NOTICE OF OPEN MEETING
AGENDA
PLANNING AND ZONING COMMISSION
City of Moberly
City Council Chambers – Moberly City Hall
101 West Reed Street
May 28, 2024
6:00 PM

Subject: *451 Sparks Ave Site Plan Review*

Subject: *1145 S Morley St Site Plan Review*

REPLAT OF CARL HAYNES SUBDIVISION FOR
BRYSON & BRYSON HOLDINGS LLC
A PORTION OF LOT 5 OF CARL HAYNES SUBDIVISION,
LOCATED IN THE NW 1/4 OF SW 1/4
OF SECTION 31, TOWNSHIP 54, RANGE 13
MOBERLY, RANDOLPH COUNTY, MISSOURI

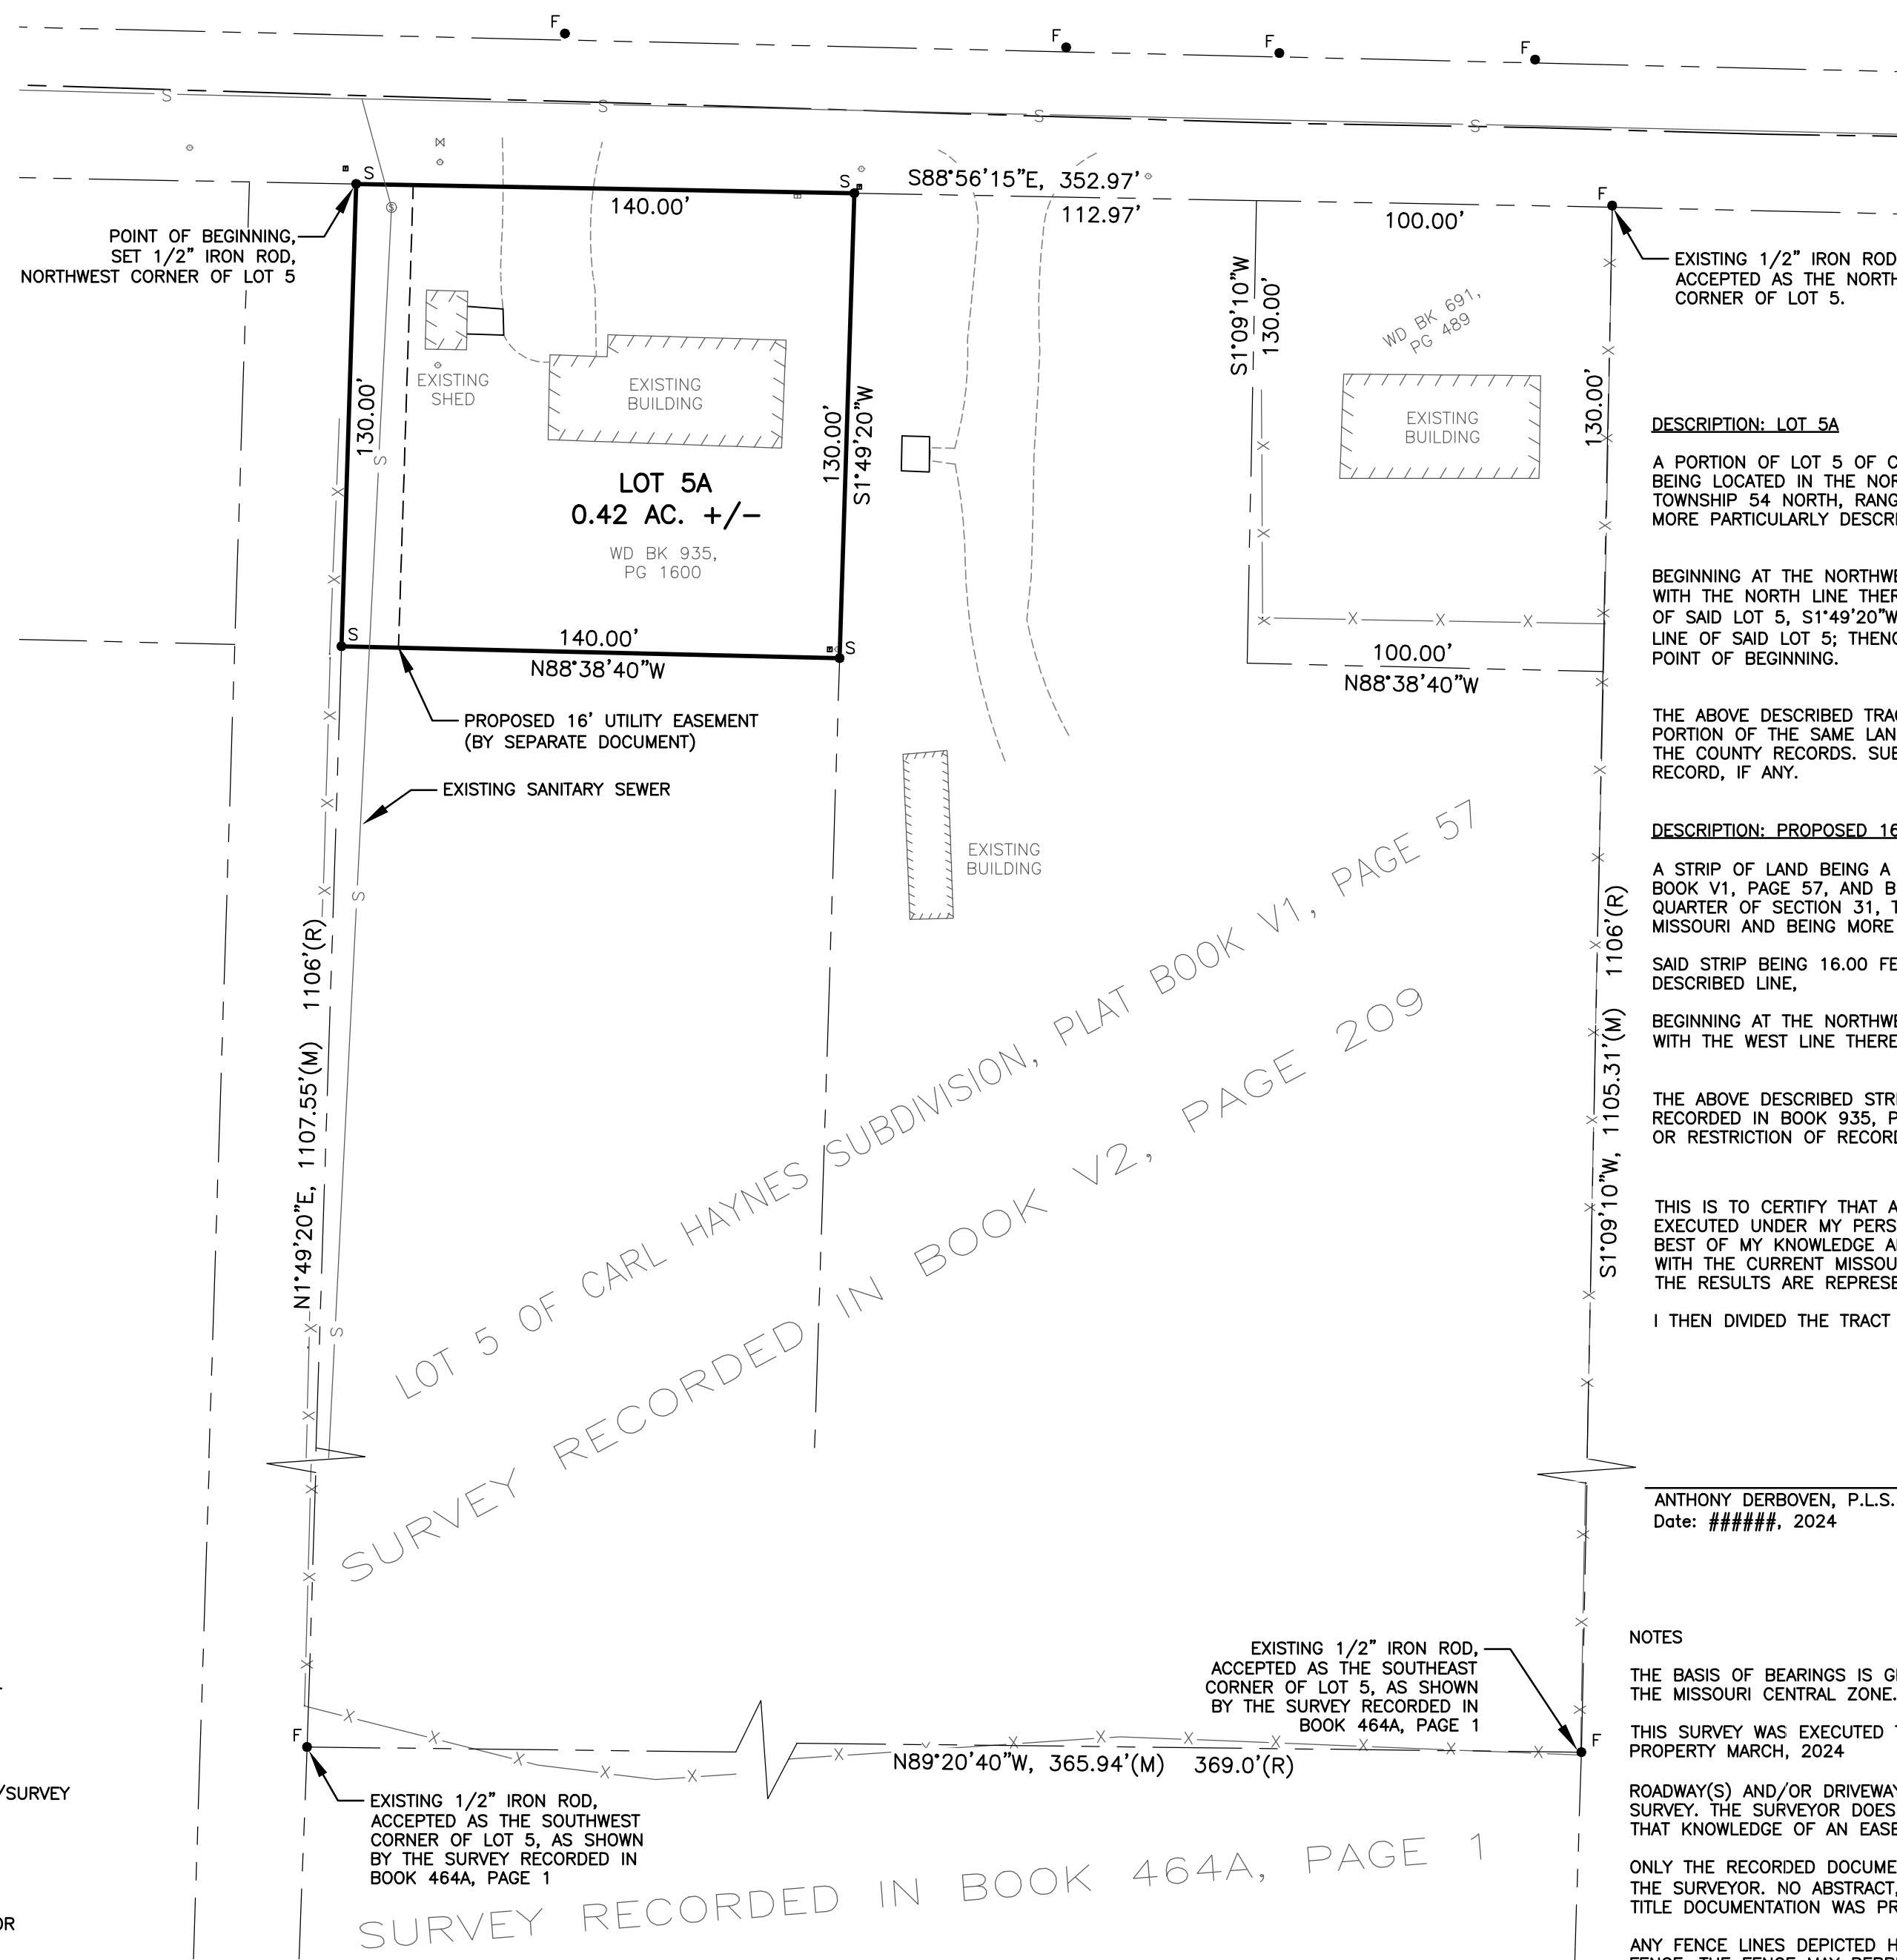
The City Staff Review recommends that the Planning and Zoning Commission consider requirement that the Re-plat also rezones the property to R-1 for Lot 5A to align with the surrounding zoning district. This shall be an amendment from the Planning and Zoning Commission and attached to the Re-plat as it is forwarded to the City Council.
